**"Transportation  
Assessment  
Report"**

**Stage 1 Road Safety Audit,  
Preliminary Travel Plan, and  
DMURS Statement of Consistency**

**Proposed Residential  
Apartment Development**

**Units 66 & 67, Fourth Ave.,  
Cookstown Ind Estate,  
Dublin 24.**

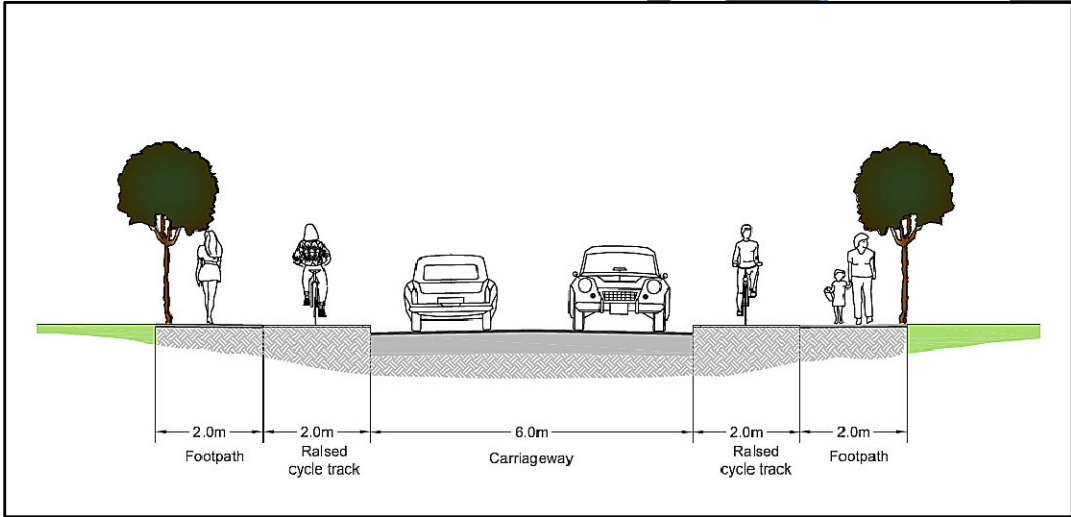
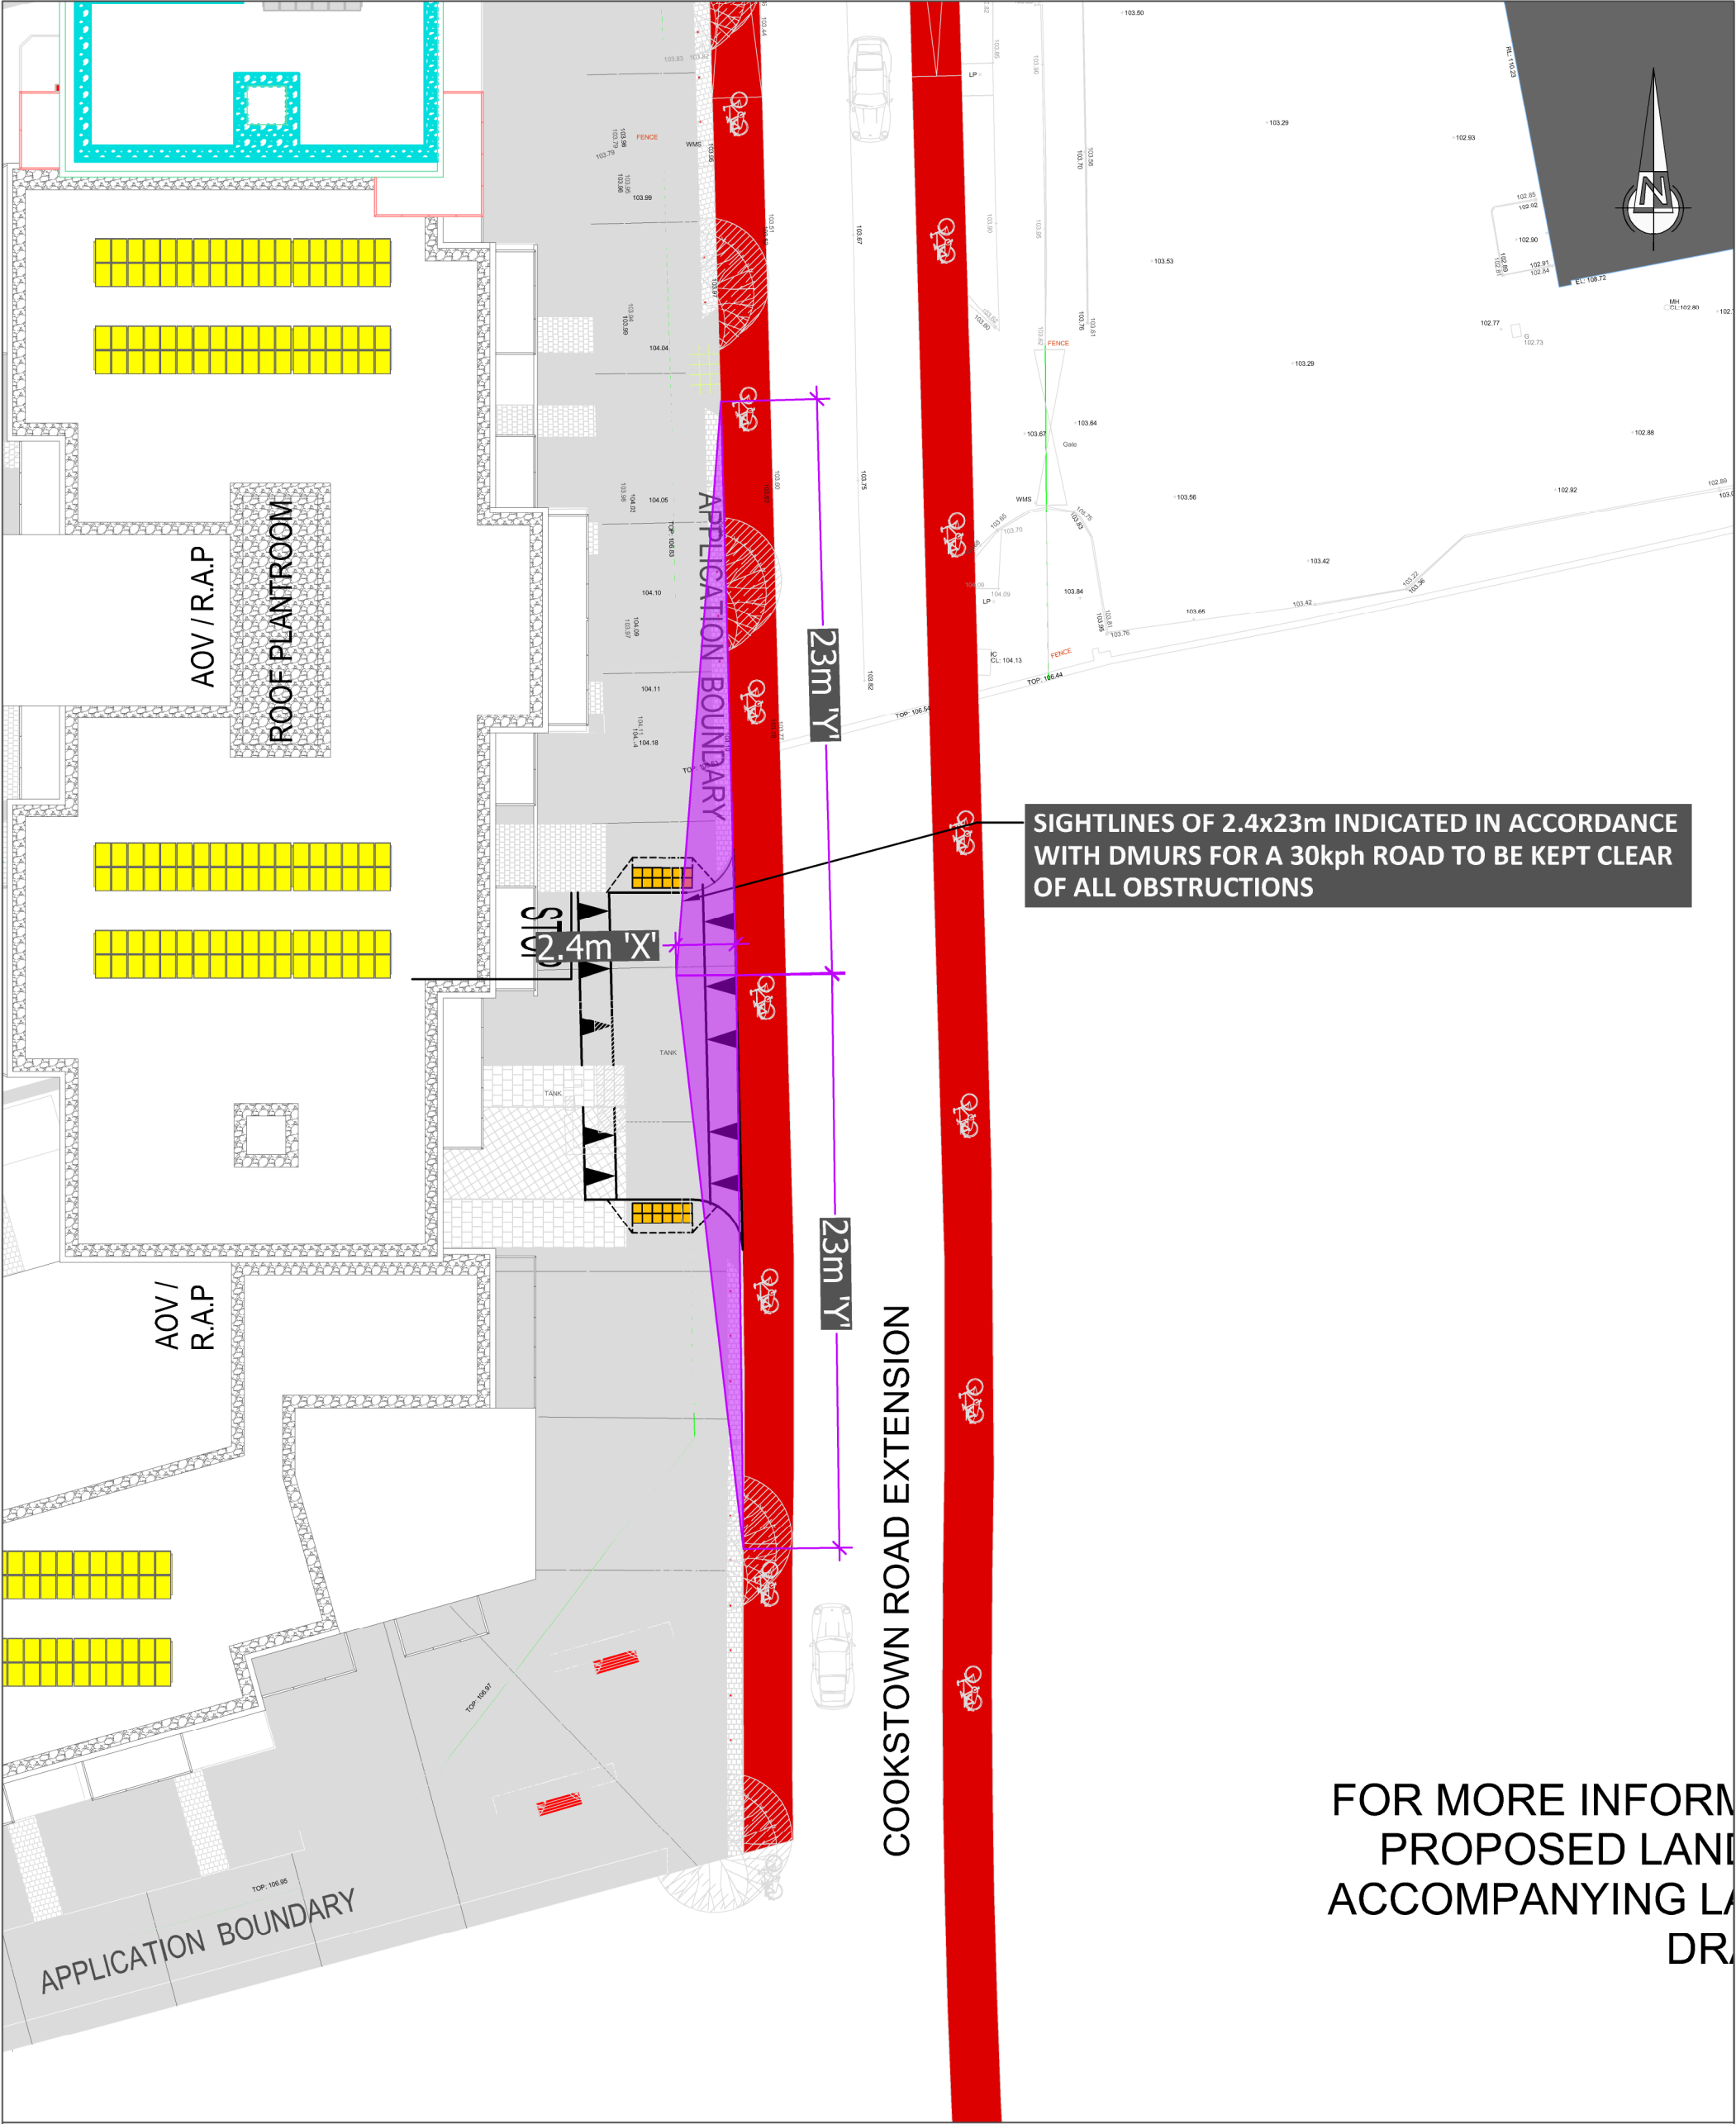
Drawing NRB-TA-001 Rev B & site observation

It is recommended that the development be completed after the link road is constructed by SDCC or that a temporary pedestrian link be provided in the interim period.

Drawing NRB- TA-001 Rev B

There are a number of informal pedestrian crossings points shown on the drawing. There are no corresponding points on the opposite side of the carriageway which could lead to trips and falls for the mobility impaired or inability to cross for buggy pushers or wheelchair users. The high “trief” type kerbs are used throughout the industrial estate which are higher to mount than ordinary kerbs and could even be treated as height hazards.

It is recommended that crossing points are provided on the opposite side of the carriageway. Where the traffic islands for the roundabout are to be used as a refuge they should have dropped kerbs and tactile paving and should be at least two meters wide to provide sufficient refuge from passing vehicles.

Drawing NRB- TA-001 Rev B & Site Observation.

It is recommended that the signs and road markings associated with the roundabout are provided in the interim until the signalised junction is provided as part of the proposed third party E-W link to Belgard Road.

Drawing NRB- TA-001 Rev B & Site Observation.

Paragraph No. in Safety Audit Report	Problem accepted (yes/no)	Recommended measure accepted (yes/no)	Alternative measures (describe)	Alternative measures accepted by Auditors (Yes/No)
3.1	Y	Y - The development is currently only at planning stage with the link road far more advanced (post tender we understand) therefore the link road will be complete by SDCC in advance of the development.		Yes
3.2	Y	Y - Uncontrolled crossing points to be provided to line up appropriately with those indicated. Exact details to be confirmed at detailed design stage.		Yes
3.3	Y	Y - Appropriate road markings and traffic signs will be detailed and provided.		Yes
3.4	Y	Y - Traffic calming measures such as build-outs to provide some deflection and/or speed reduction ramps will be provided at detailed design stage.		Yes
